Windsor Bridge Replacement Project
*Traffic Review and Information Provided by the Applicant (Roads and
Maritime Services)*

FINAL REPORT

*Prepared for NSW Department of Planning and Infrastructure
15 August 2013*

Figure 2.1.2a: Option 7 (from OptiMaster)

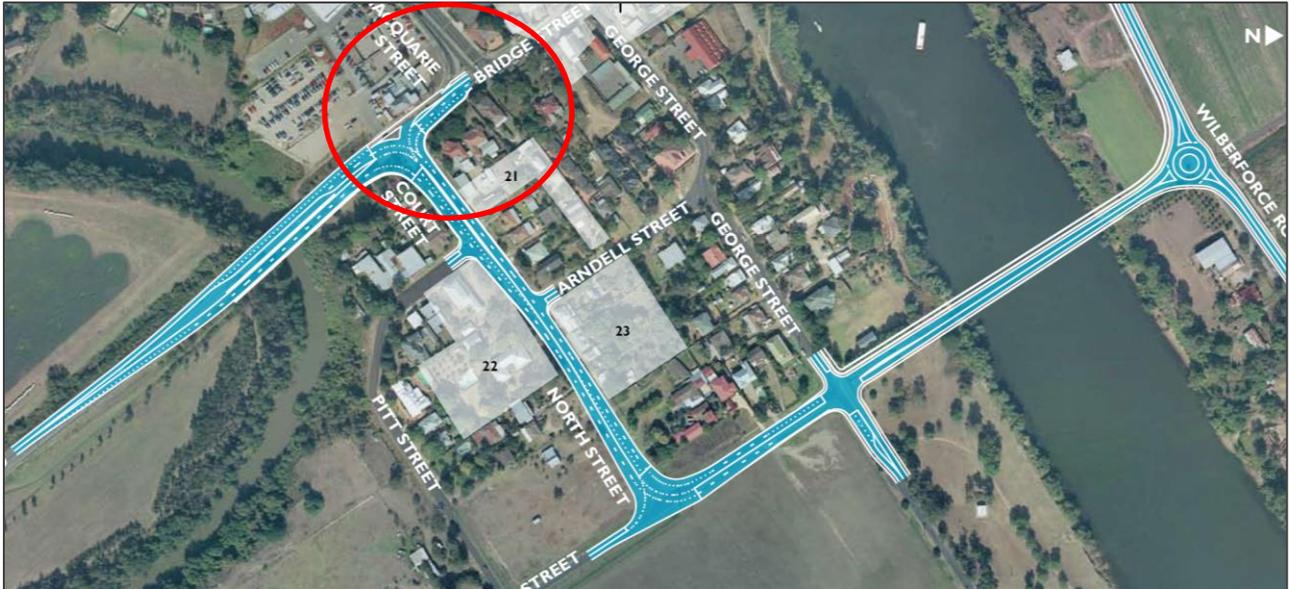
We note that the group determined that Option 7 (see Figure 2.1.2a below) would have major heritage impacts and would create potential traffic safety issues on the basis of these two issues.

This option, which involves replacement bridge designed with Palmer Street (and upgrades along the Court Street North Street route to access this bridge) and the signalisation of the Windsor Court Street intersection to cater for increased traffic movements into and out of Court Street under this scheme.

It appears (from the Traffic Modelling and Evaluation of Options Preliminary Report referred to by the applicant) that the proposed signalised Windsor Road / Court Street intersection, together with the existing Windsor Road / Macquarie Street signals.

- < the signalisation of the Windsor Road / Court Street intersection may be feasible, provided the signal and timing arrangements at both intersections are carefully considered. Coordination of the phasing at these closely spaced intersections may enable the queuing issues identified by the applicant to be at least minimised and
- < the current Windsor Road / Court Street intersection is less than ideal from a safety perspective due to existing sightline issues, and the signalisation of this intersection may in fact enable these existing issues to be addressed.

Figure 2.1.2b: Option 7 Heavy Movements at Macquarie Street and Court Street Intersections

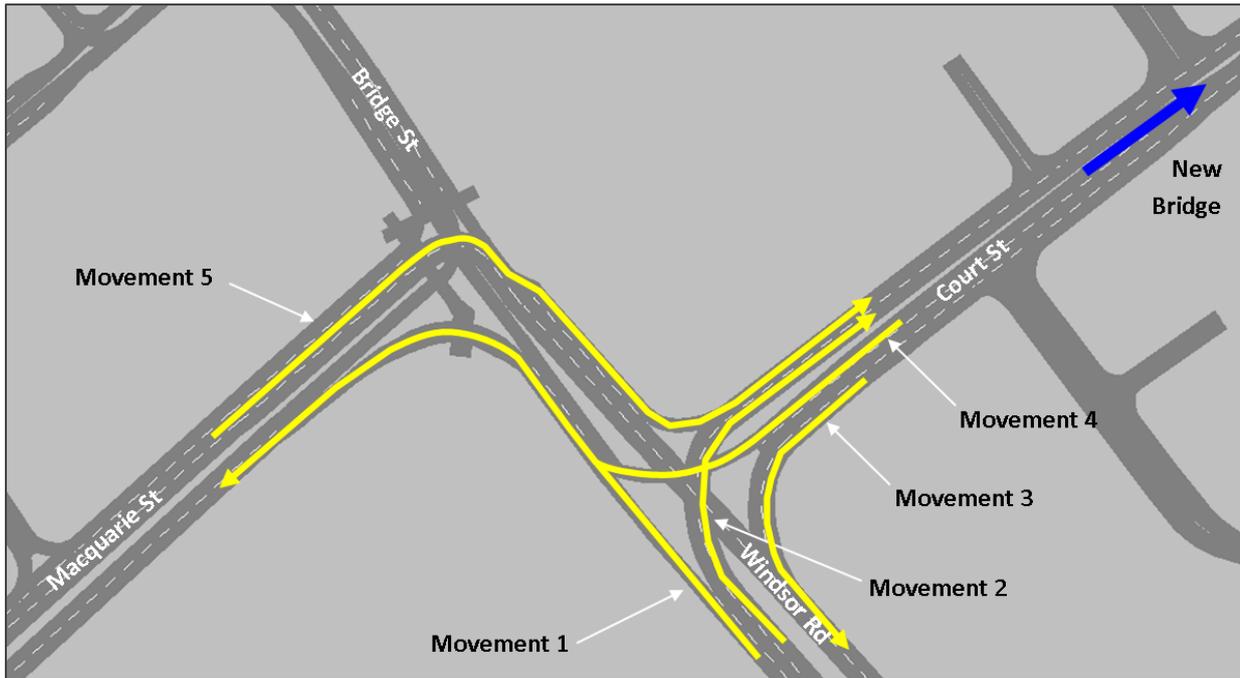
We have considered the likelihood of queuing as a result of these heavy movements and our comments are as follows:

Movement 1: The left turn into Macquarie Street is a continuous movement (opposed only by a zebra crossing) and therefore we expect that queuing back is unlikely to be an issue for this movement

Movement 2: Two right turn lanes into Court Street are proposed under this option, therefore there would be reasonable capacity for this movement. In addition, there is no upstream intersection in close proximity Windsor Road, therefore we expect that queuing back is unlikely to be an issue for this movement

Movement 3: Two left turn lanes from Court Street are proposed under this option, therefore there would be reasonable capacity for this movement. In addition, the upstream intersection in close proximity Windsor Road is Court Street, therefore we expect that queuing back is unlikely to be an issue for this movement.

Movement 4: After the right turn from Court Street, the left turn into Macquarie Street is a continuous movement (opposed only by a zebra crossing), and therefore we expect that queuing back is unlikely to be an issue for this movement

Movement 5: We expect that the signal phasing at these two intersections could be coordinated for this movement, to minimise the likelihood that the left turn into Court Street queues back to the Macquarie Street intersection.

In summary, based upon the information we have been provided, we consider that Option 7 warrants further consideration, from a traffic perspective.

Figure 2.1.2 Option 7 Possible Future Alignment of Macquarie Street (Concept Only)

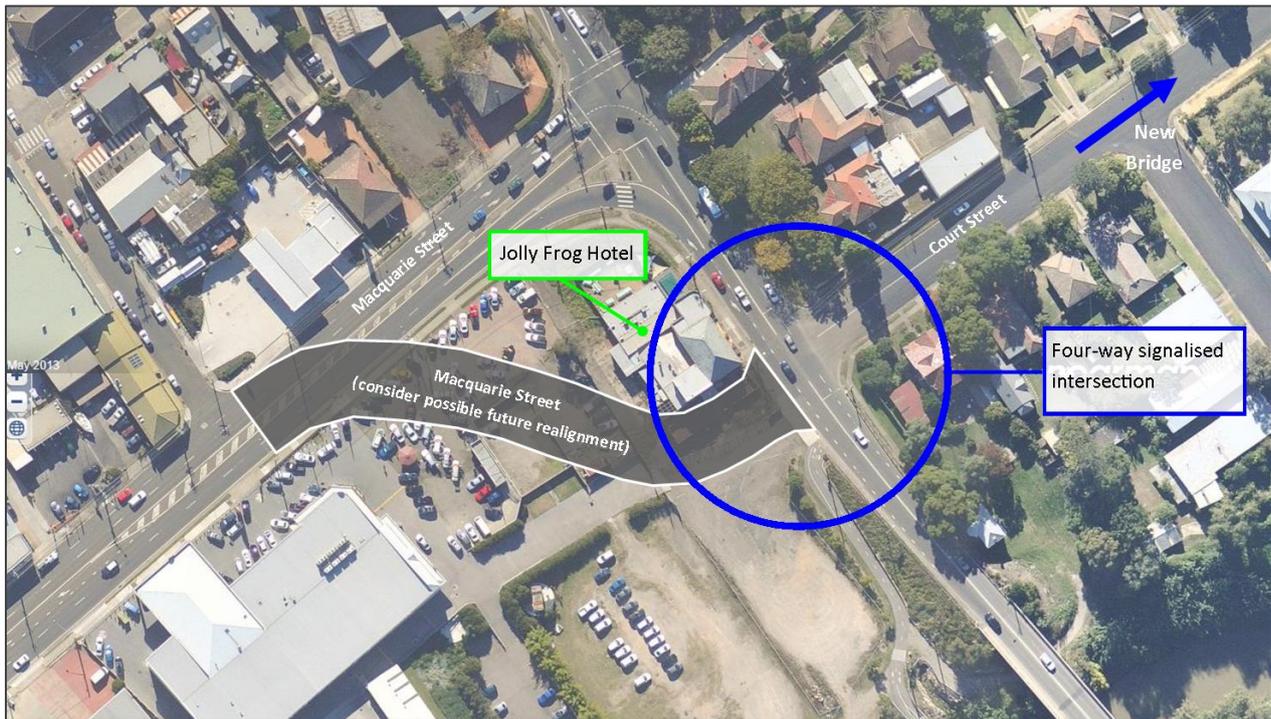
The realignment of Macquarie Street as shown in the figure above would clearly have property impacts understood that the Jolly Frog Hotel (formerly the Tavern) is of local heritage significance (see Figure 2.1.2d below), however we also understand that this hotel is currently not operational, and is considered by some to be in need of restoration.

There may be an opportunity to realign Macquarie Street to form a four-way intersection with Court Street, minimising impact upon the Jolly Frog Hotel. The Court Street and Macquarie Street approaches could potentially be offset whilst still operating as a four-way intersection. This may avoid or at least minimise physical impact upon the Jolly Frog Hotel.

We would suggest that this arrangement could be considered as a possible future road realignment, where the government could seek to progressively acquire the property and when the operation of the closely spaced intersections of Court Street and Macquarie Street is no longer required.

We acknowledge however that this option would increase traffic volumes past a number of residential properties along Court Street and North Street, as well as several heritage / cultural precincts and properties, and this would be a consideration of this option.

Hawkesbury Valley Way / Macquarie Street intersection

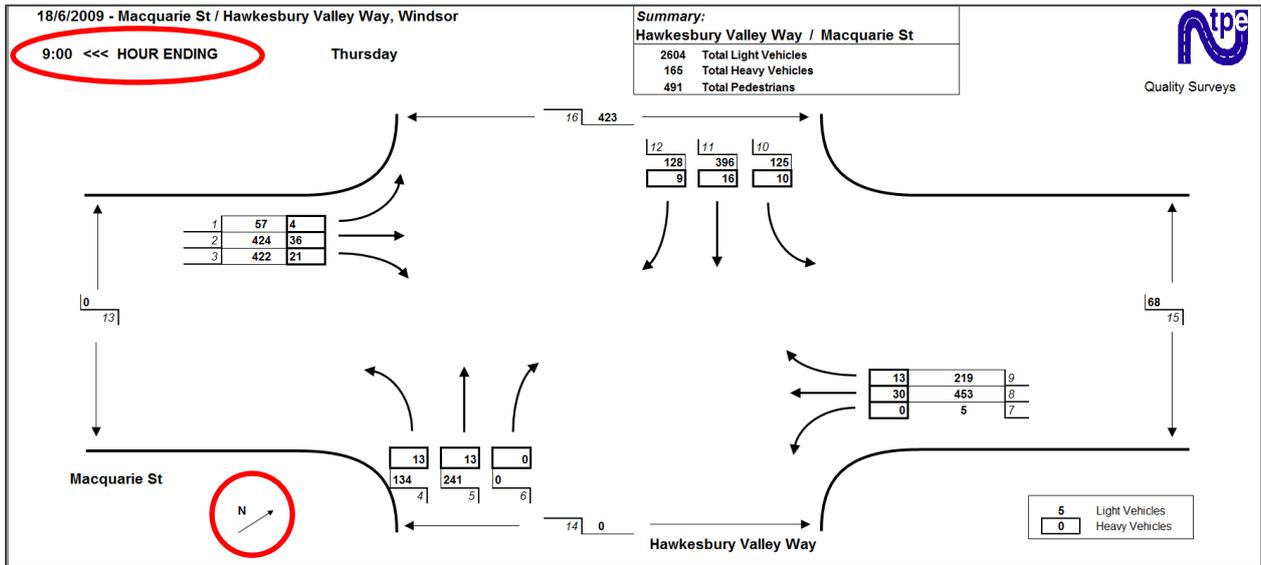
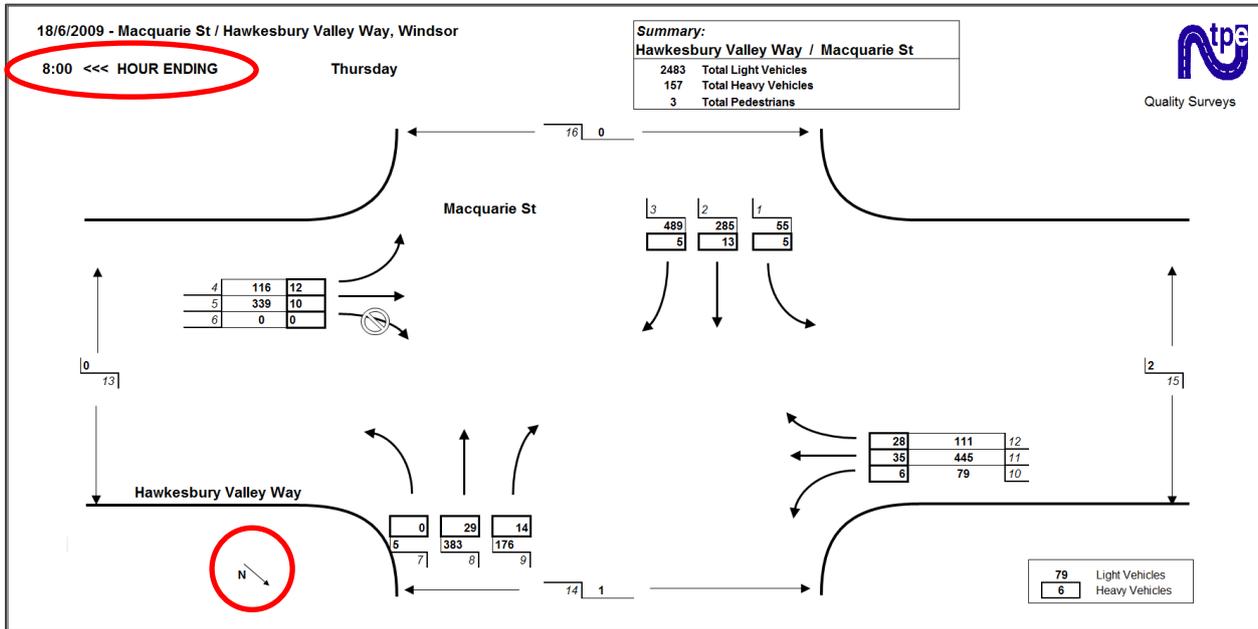
Whilst these two figures appear to provide the results of traffic counts taken at the same intersection on the same day we note that the total intersection volumes presented in each of these figures is quite different (2769 vph in Count 1, 3040 vph in Count 2, for the time period from 9:30am to 1:00pm). Note the orientation of the intersection in each of these figures is different.

Conflicting Movement SIS SIDRA Model Configuration

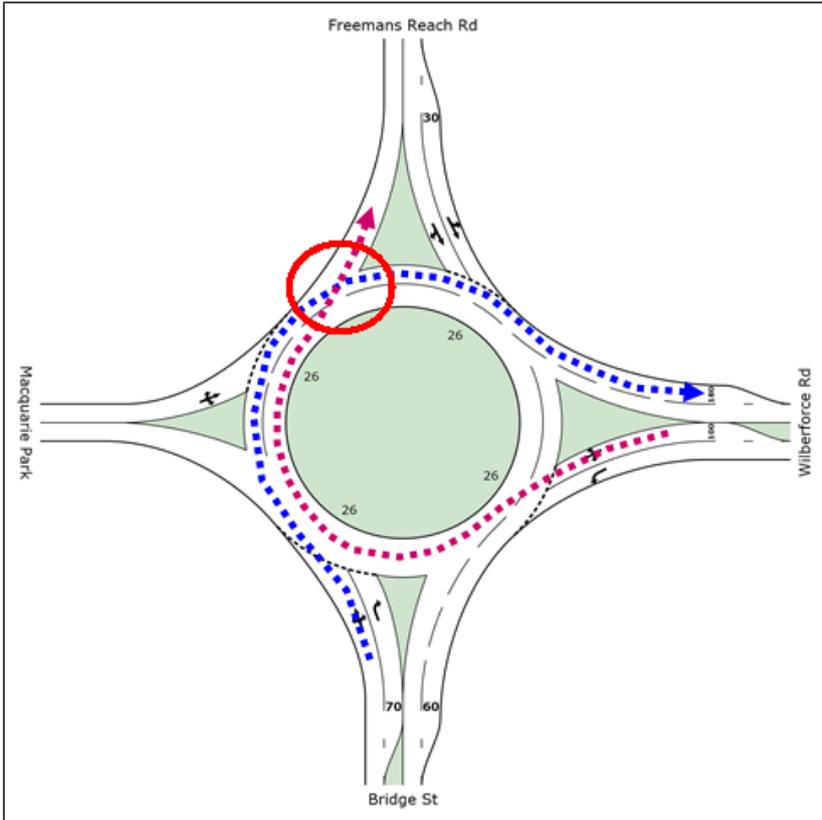
We expect that the movements may be different in the concept design due to conflicting movements on the roundabout if the lane designation was assumed in the SIDRA model (see figure below)

It would appear as though the SIDRA modelling may not have been updated to reflect the amended lane design as shown in the Concept Design. This however is just our assumption and should be confirmed with RMS.

Note: While this arrangement is legally acceptable and does occur at some roundabouts, it is preferable to an arrangement where possible.

Bridge Street / George Street Intersection

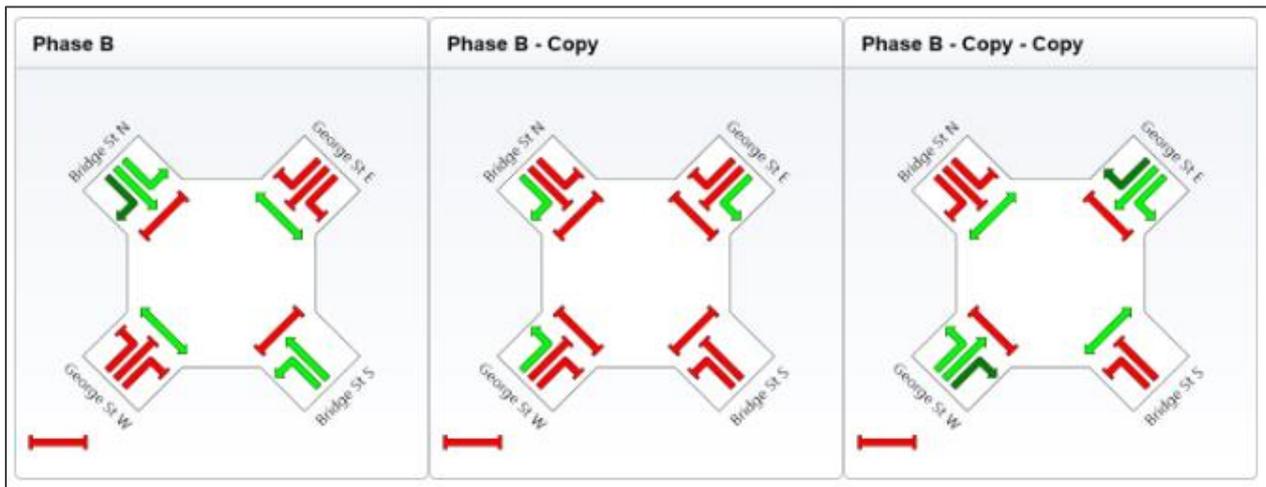
We would recommend that alternative phasing arrangements, which do not include filter movements from shared lanes or right turn movements filtering through pedestrian movements, be pursued if possible.

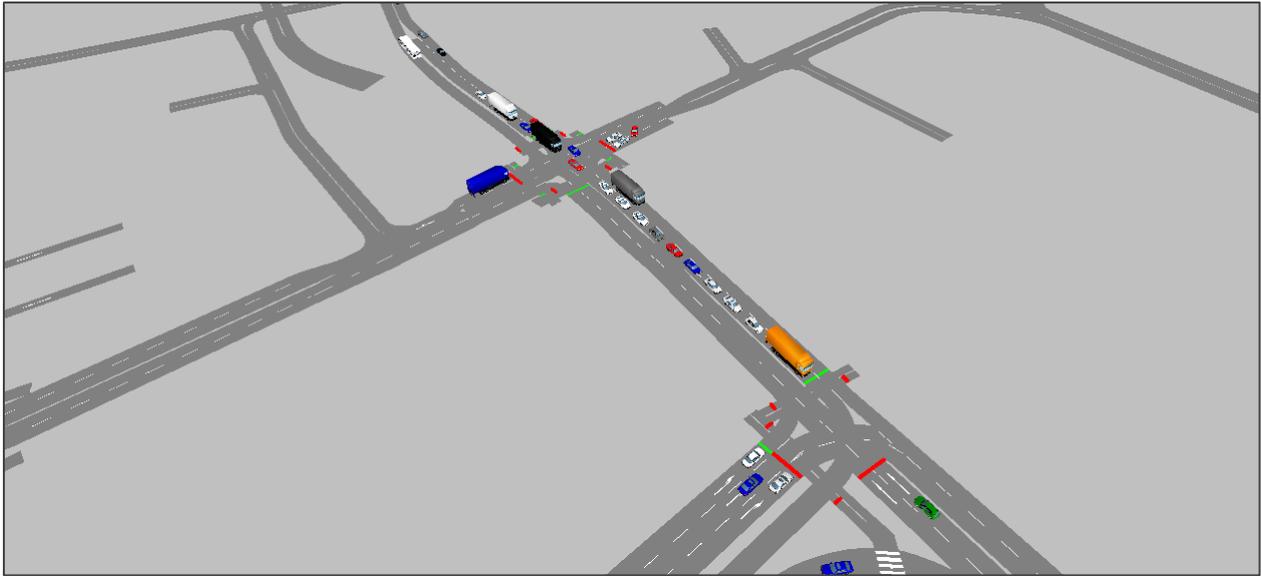
- ◁ As indicated in the figures overleaf, the (future) additional southbound lane on the bridge would appear to offer little benefit other than to accommodate queuing back from the George Street and/or the Macquarie Street intersections.

- ◁ It appears as though the following vehicle speeds on the bridge have been applied:
 - o 60km/hr northbound; and
 - o 80km/hr southbound.

These speeds should be adjusted to the speed assumed in the design of the preferred option (50km/hr).

Figure 2.6.12a: Roundabout components

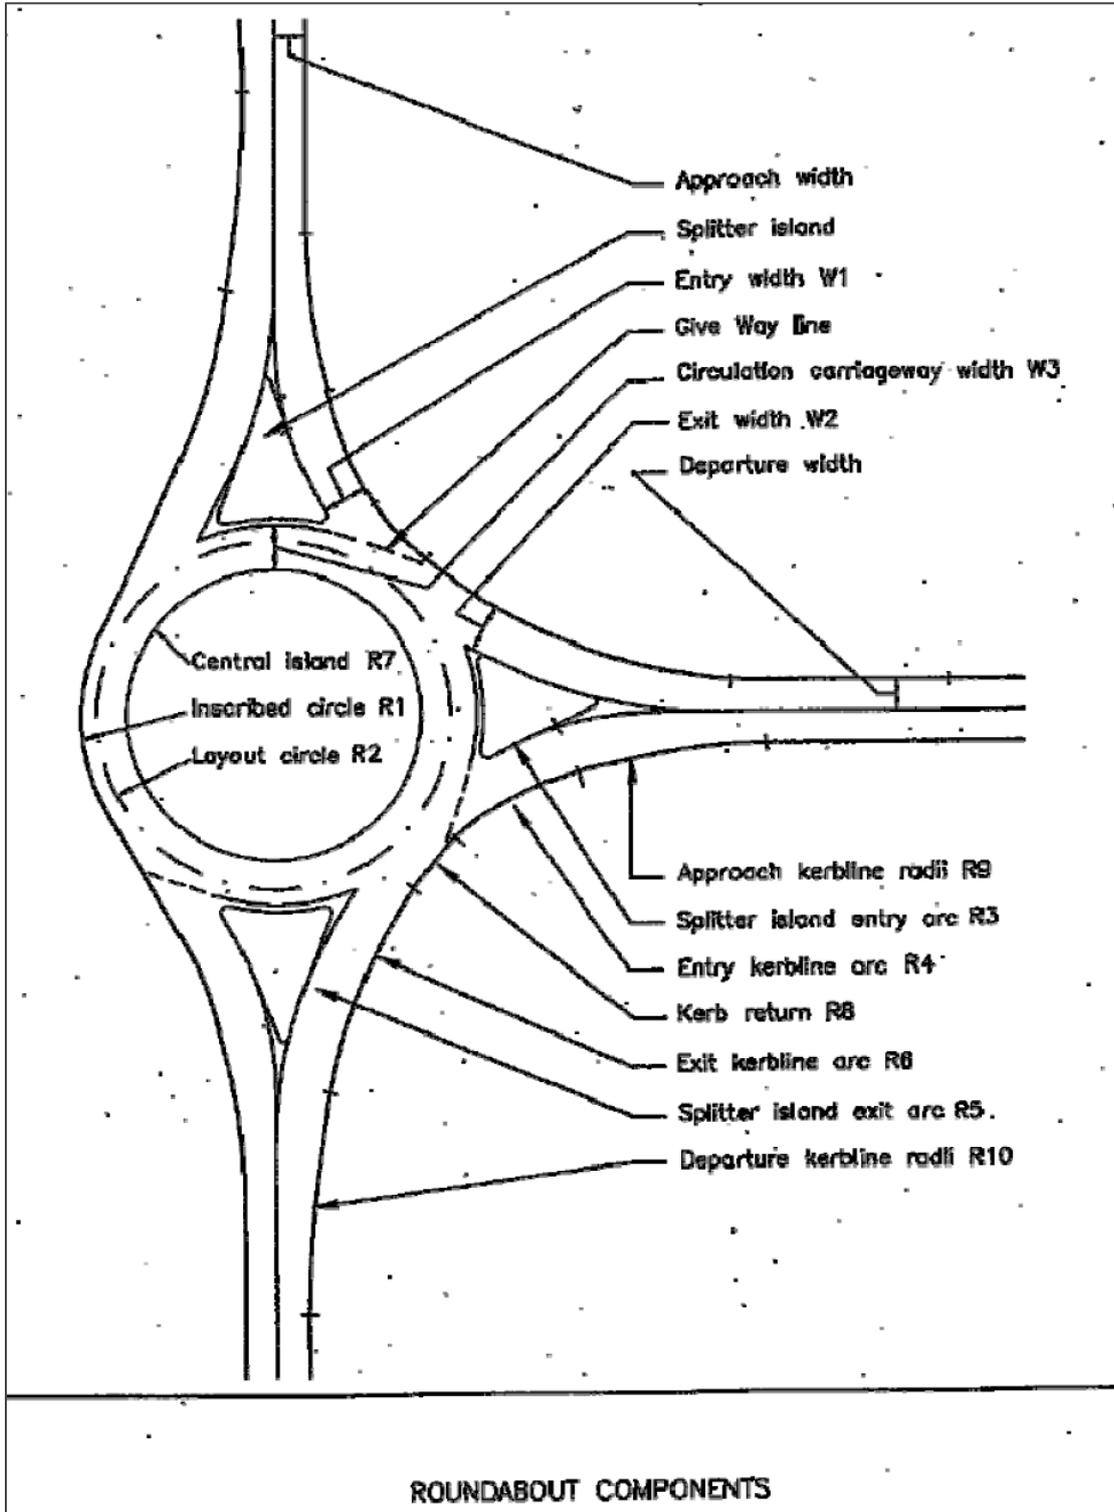
We have undertaken a high level review of the configuration of this roundabout against the relevant requirements (see Figure 2.6.2 overleaf). A summary of the results of this assessment is provided in Table 2.6.12 below.

In summary, the roundabout design appears to be generally in accordance with the requirements (subject to checking deflection), with the exception of the island entry (R3) on the southern approach. This should not exceed 100m, to limit the speed of vehicles entering the roundabout.

Figure 2.6.12b: Double Manoeuvring through Proposed Northern Roundabout

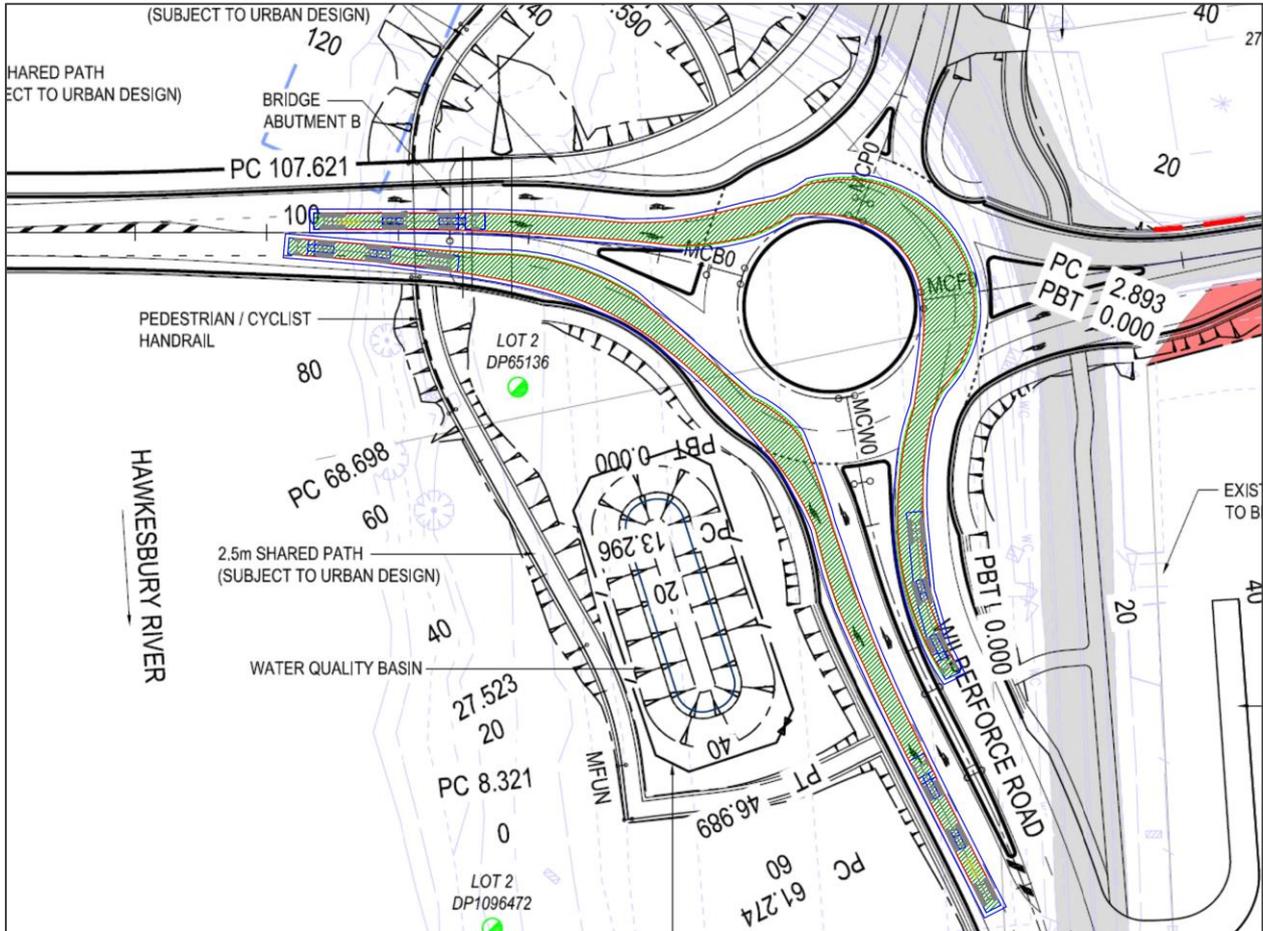
We have also checked the manoeuvring of a double vehicle through this roundabout (see 2.6.12) and the results indicate the geometry is adequate to cater for these vehicles.
